MEMORANDUM

From:	Ben Amey Development Control		
Service	WBC Highways	App No:	251105
Address:	The Sapphire Centre, Fishponds Road, Wokingham, RG41 2QL		
Proposal:	Proposed Extension to the Rear of the Existing APACOR Facility by Connecting with an Existing Commercial Building to the Rear with associated works		
Site Visit Made:	Yes (10 th and 11 th June 2025)

Consultation Response

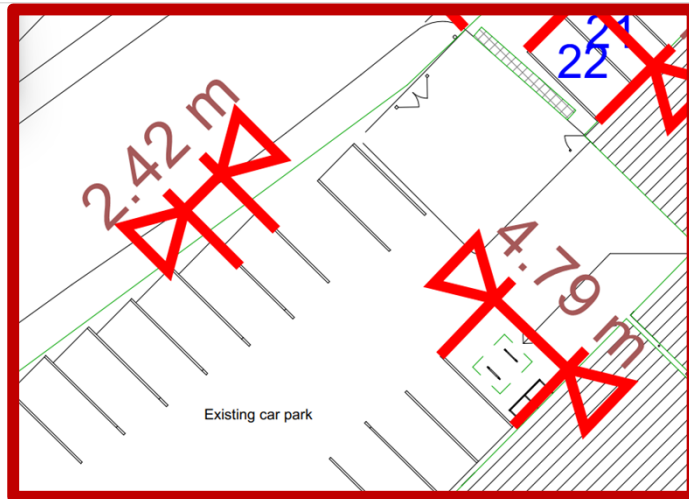
8. The existing car parking was observed to be fully occupied by existing staff during a site visit on 11th June 2025. Therefore, the LHA is concerned that the proposals do not provide car parking in accordance with the WBC Car Parking Standards, given an enlarged building could increase no. of staff and parking demand. Photos of car parking occupancy on 11th June 2025 are provided below:
